#15708: Customer Satisfaction - Water Leak onto Left Cabin Floor - (Nov 19, 2015)

Subject: 15708 - Water Leak onto the Left Cabin Floor

Models: 2016 Chevrolet Colorado

2016 GMC Canyon

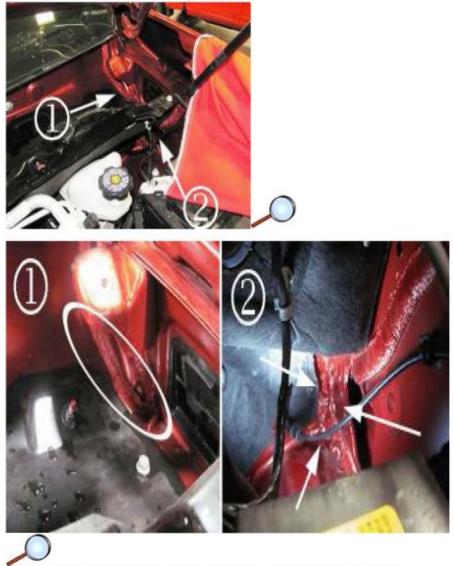
Note: The following repair steps involve resealing the cowl/plenum area and the driver side hinge pillar. When sealing these areas, inspect the surrounding body seam sealer for voids, gaps, or missing material. Reseal all seams as required.

5. Apply seam sealer to the above (1) and the below (2) seams as shown above.

- 1. Open the hood and install fender covers.
- 2. Remove the windshield wiper motor. Refer to Windshield Wiper Motor Replacement in SI.
- 3. If required, clean any dirt or loose debris from the seam to be sealed.
- 4. Using a general purpose adhesive cleaner, clean the area to be sealed.
